OFFICE / WAREHOUSE Lot 4, Alameda business Center Albuquerque, NM		#01-27
SITE PLAN / TRAFFIC CIRCULATION BILL BURK, THIRD, ARCHITECT 9617 La Playa NE Albuquerque, NM 87111 (505) 292-6566		1 1/

A PROPOSED GRADING AND DRAINAGE PLAN FOR OFFICE/WAREHOUSE  
 8633 PASEO ALAMEDA N.E.  
 ALBUQUERQUE, NEW MEXICO  
 FEBRUARY, 2002

OFFICE / WAREHOUSE Lot 4, Alameda business Center Albuquerque, NM <b>SITE PLAN / TRAFFIC CIRCULATION</b> BILL BURK, THIRD, ARCHITECT 9417 La Playa NE Albuquerque, NM 87111 (505) 292-6566		#01-27 1 1/
---	--	-------------------

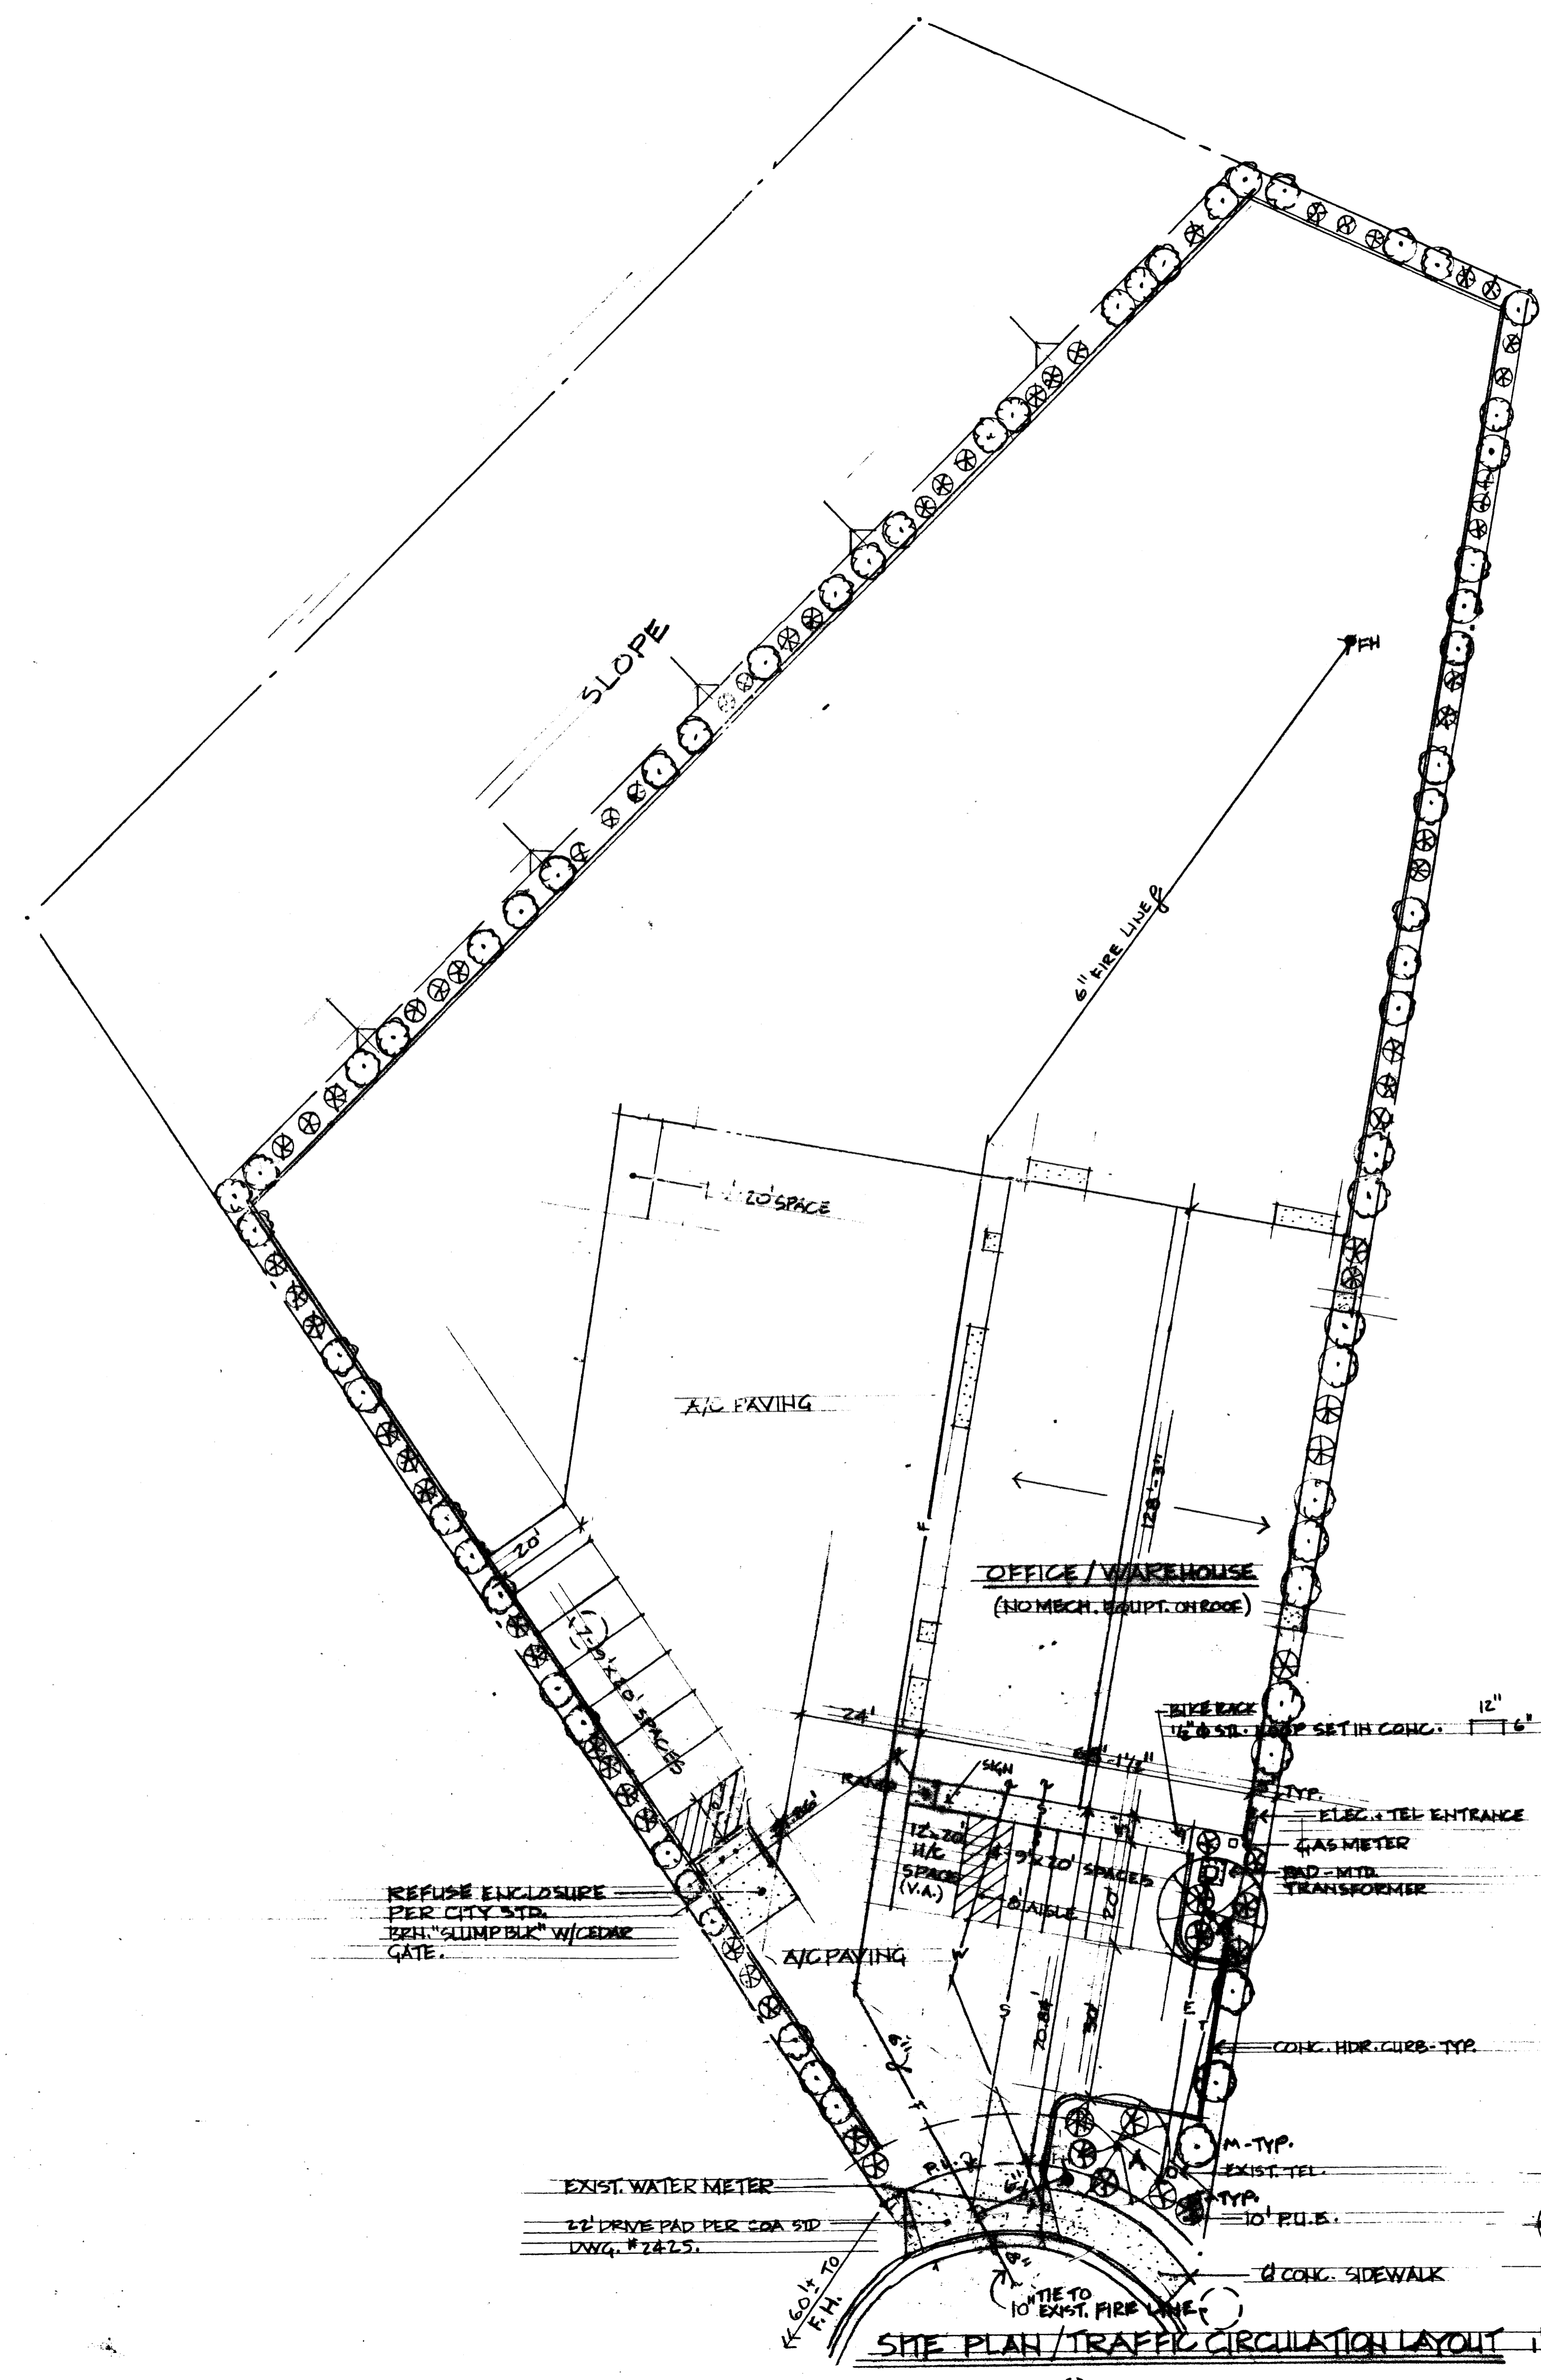
~~DELETED - SEE ATTACHED LANDSCAPING PLAN~~

#22-02 REVISIONS PER DRB.

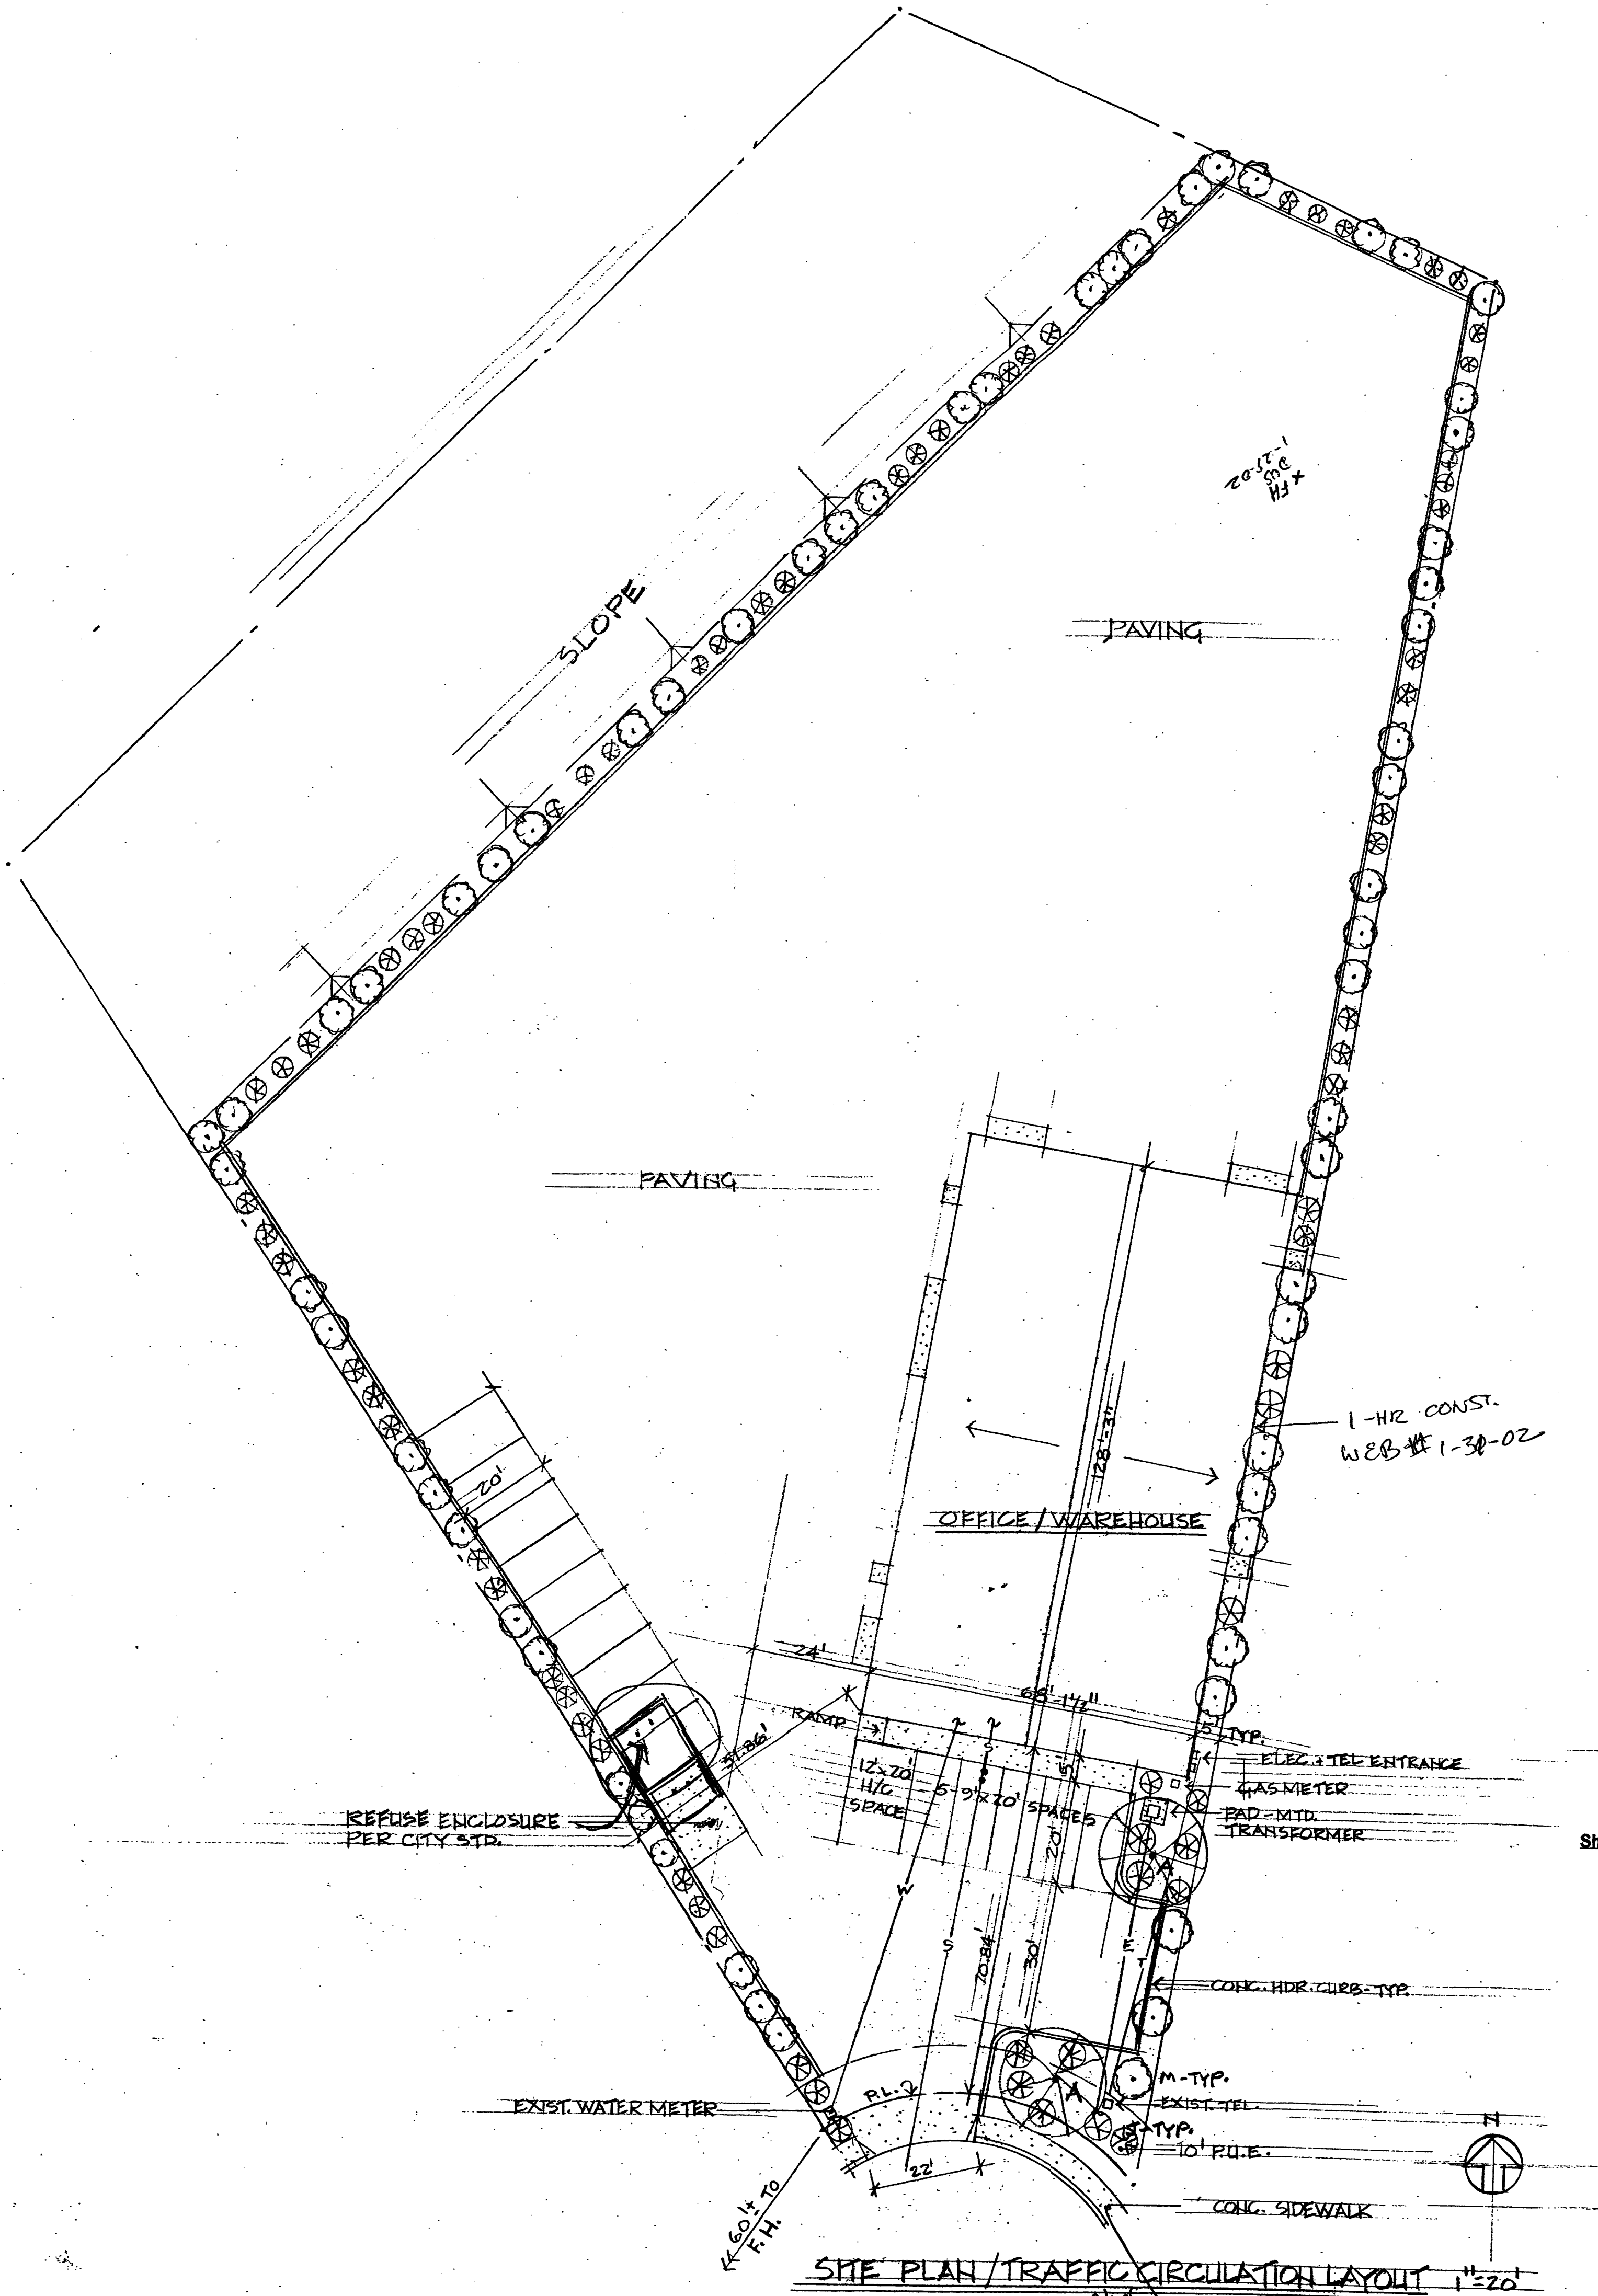
Allow area = 8,000 sq ft  
 WEB # 1/31/02  
 2 side increase 12,000 sq ft

DESIGN CRITERIA	
ZONING:	SU-2 IP-EP
OCCUPANCY:	8.5-2 (S-1) WEB # 1/31/02
CONSTRUCTION TYPE:	V-N
LEGAL DESCRIPTION	
Lot 4, Alameda Business Center Albuquerque, NM	
OFF-STREET PARKING/BUILDING AREAS	
OFFICE	1712 sq ft + 200 = 9 spaces
WAREHOUSE	6448 sq sf + 2000 = 4 spaces
REQUIRED FURNISHED	13
(including one van-accessible space)	13
ALL CONTRACTORS SHALL VERIFY ALL DIMENSIONS AND EXISTING CONDITIONS
